Product Change Notice (PCN)

PCN Number: PCN-0374233R-01

Product(s) Affected: CSS-0575A-SMT-TR and CSS-0578-SMT-TR

CSS-0575A-SMT-TR – Previous: SPL 75 dB / Current Consumption 110

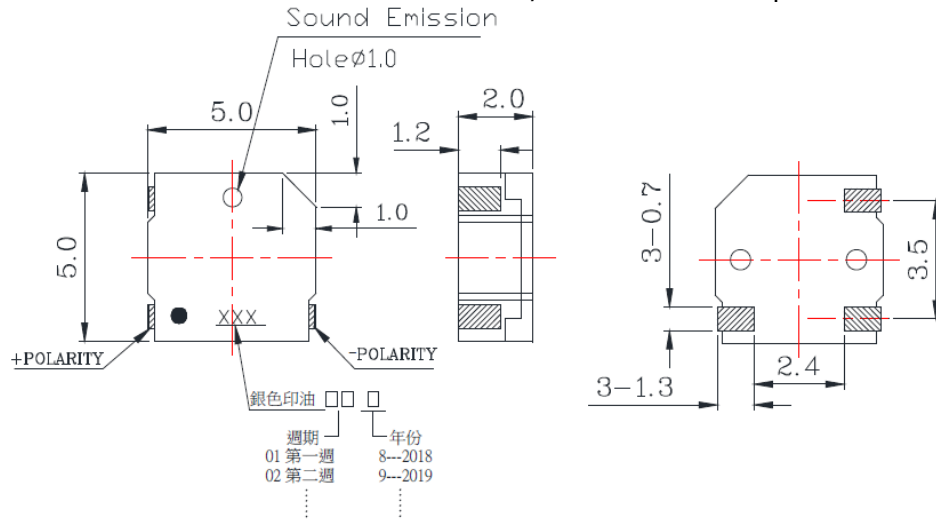
Description of Change: Tooling has been altered creating higher SPL, lower consumption current due to optimization of the structure and new dimensions are very close to the previous while the PCB layout remains the same for both parts.

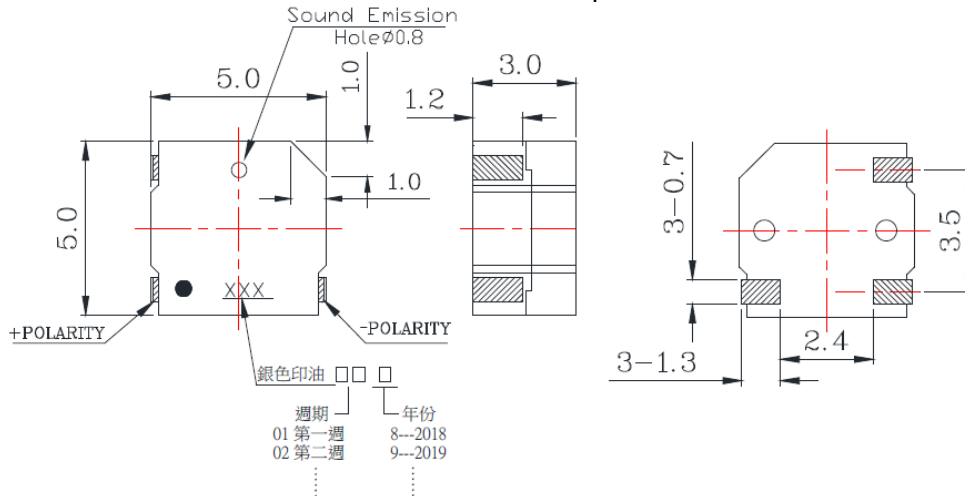
CSS-0578-SMT-TR – Previous: Current Consumption 110

CSS-0578-SMT-TR – New: Current Consumption 95
